# SCOTTISH HOSPITALS INQUIRY

## **Bundle 13 – Miscellaneous**

### **Volume 5**

Figure 1: Supply and extract ventilation as recommended in SHTM 03-01 and as per Project Co's Design

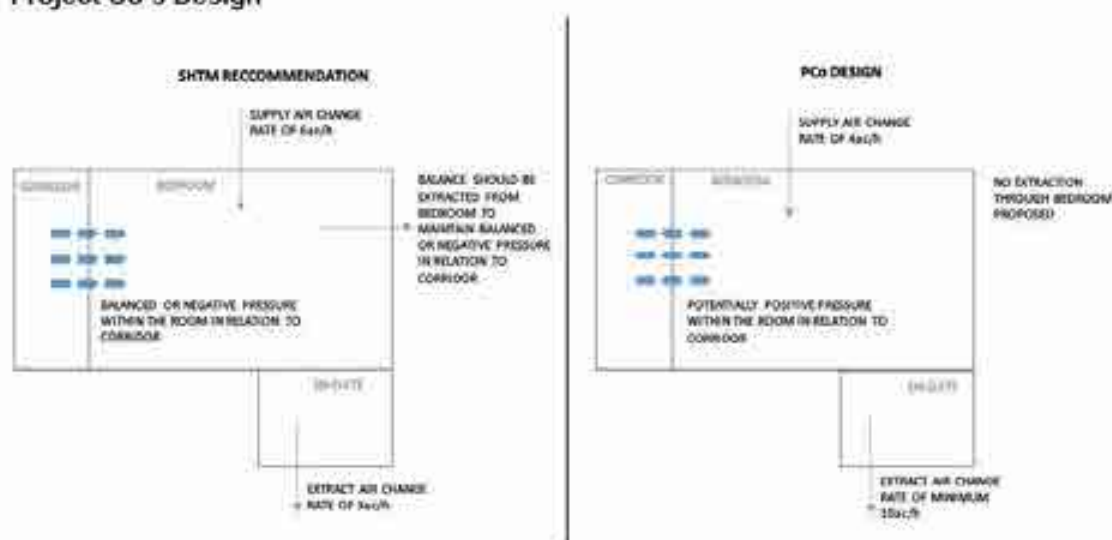
The Board has produced the following schematic to illustrate the principles for supply and extract ventilation as recommended in SHTM 03-01 and as per Project Co's Design.
